# GENERAL ELECTRIC

Subject: GE-NEBG Organizational Changes

In Licensing Topical Report NEDO-11209-04A, the General Electric Company has committed to notify the NRC of organizational changes affecting the BWR QA Program within thirty days after implementation. In compliance with this commitment, notification of organizational changes effective July 1, 1979, as documented on the attached draft chart, "Figure 1-1 Nuclear Energy Business Group," (page 1-11 of NEDO-11209-04A), is transmitted.

Figure 1-1. Nuclear Energy Business Group 7/1/79

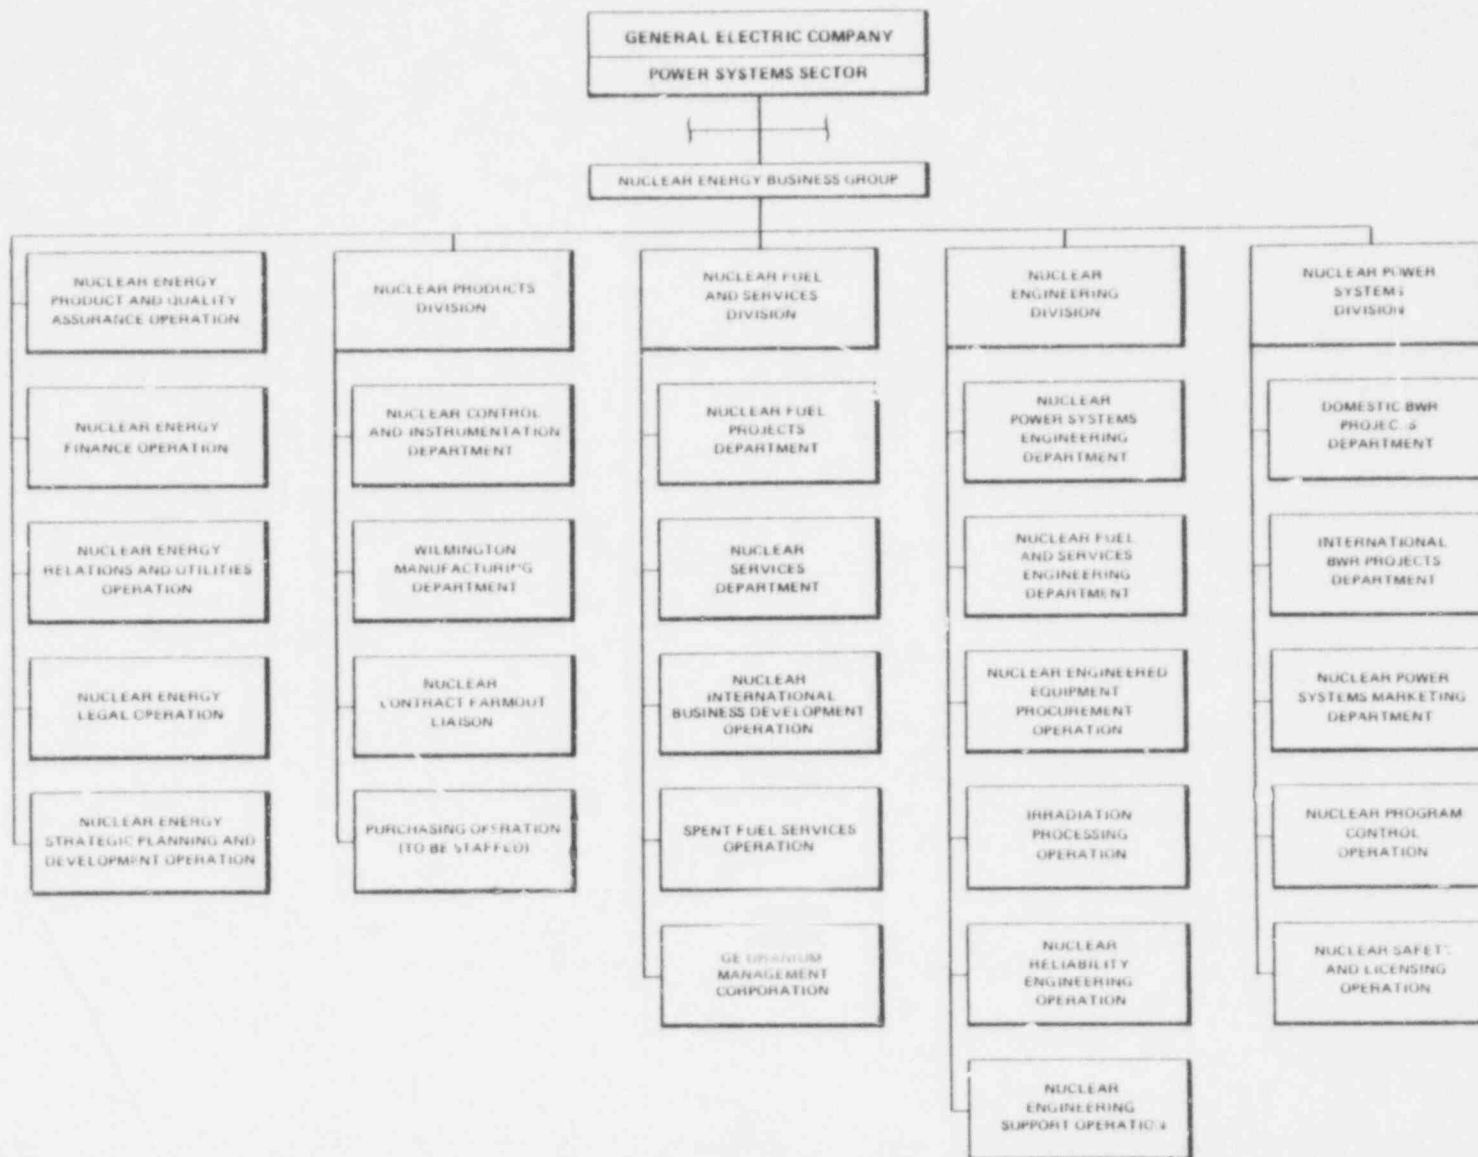
The principal project management organizational changes are reflected in the establishment of two new division-level components: the Nuclear Fuel & Services Division and the Nuclear Power Systems Division. Concurrently, the former Nuclear Energy Programs Division and the Nuclear Energy Projects Division were discontinued. The reorganization places project management responsibility for nuclear fuel-related activities and management responsibility for nuclear services in the new Nuclear Fuel & Services Division. The reorganization places project management responsibility for nuclear steam supply systems in the new Nuclear Power Systems Division.

The principal product design organizational changes are reflected in a realignment of responsibilities within the Nuclear Engineering Division with the establishment of the Nuclear Power Systems Engineering Department and the Nuclear Fuel & Services Engineering Department, and the concurrent discontinuance of the BWR Systems Engineering Department and the Nuclear Technology Department. This reorganization places basic responsibility for nuclear steam supply system design in the new Nuclear Power Systems Engineering Department and for nuclear fuel and services design in the new Nuclear Fuel & Services Engineering Department.

In this reorganization no quality-related functions were discontinued. Other changes below the Department/Operation level are in the process of review and approval and will be transmitted to you as changes to the organizational charts on pages 1-12
